1. PURPOSE AND SCOPE OF THIS MEMORANDUM

This memorandum summarizes a site survey performed on July 18, 2008 to evaluate the condition of ADA-mandated accessibility at the Fire Station in Pembroke Massachusetts. After a description of the site and interior conditions of the building, recommended improvements are provided in Section 7, beginning on page 8.

The subject property is the Pembroke Fire Station at 172 Center Street, at the corner of Elliot Avenue.

ii. Directional signage to primary uses within building

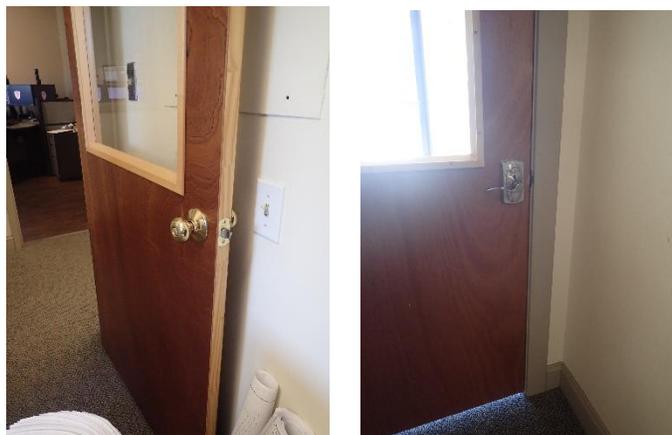
The interior signage provided at the Fire Station is limited and typically does not meet ADA standards. Some permanent rooms and spaces are clearly identified, but the signage is not mounted at consistent heights or locations and lacks the required raised lettering and Braille characters.

However, we note that most public access to the Fire Station is limited to the main entrance vestibule.

Provide consistent ADA-standard signage for all accessible doorways, routes and spaces.
